TSB # 625-0043
Prince Castle
355 East Kehoe Blvd
Carol Stream, IL 60188
Date 7/7/17

In a going effort to ensure quality on our Genuine OEM Equipment, we are Issuing a Technical Service Bulletin for our 625-MFY Series Steamers. This Bulletin will indicate new product time changes to accommodate for new bread product, along with silicone tube (OEM PART # 625-359S) replacement and proper regulator pressure to ensure Gold Standard Product. **Please note this programming change and PM is not covered under any Prince Castle OEM Warranty.**

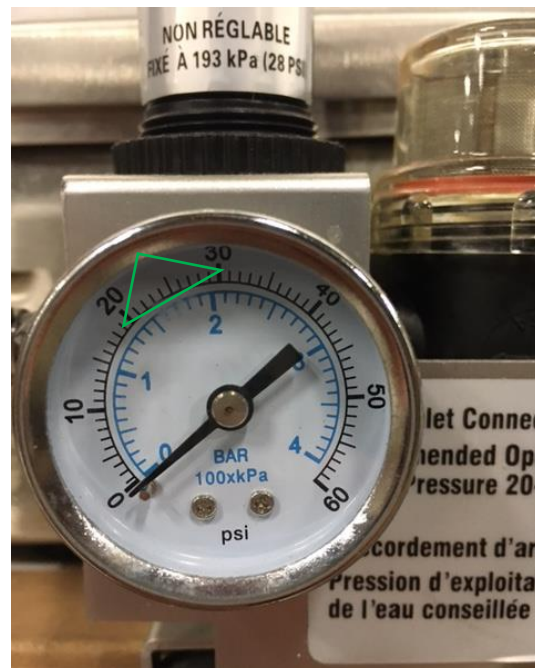
Old Settings
0.5 sec on
1.0 sec off
6 Cycles
2.5 alarm

New Settings
.6 sec on
2.5 sec off
1 Cycle
2.5 alarm

Follow Video Instructions below to change to the new settings listed below.
